## Proposed changes to support protection with load sharing

### 26.10 Protection Switching for Point-to-Point PBB-TE TrunksServices

**Protection Switching State Machine**

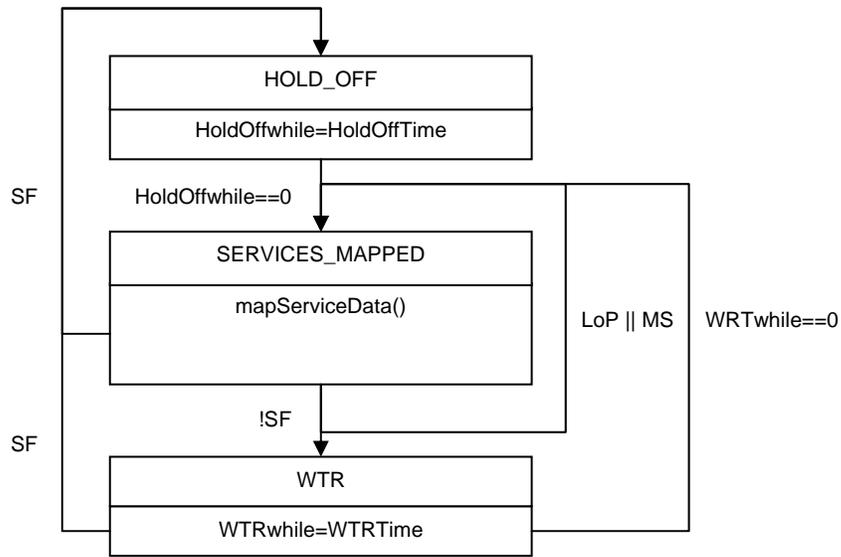
(page 77) Change the Protection Switching State Machine diagram to the following:
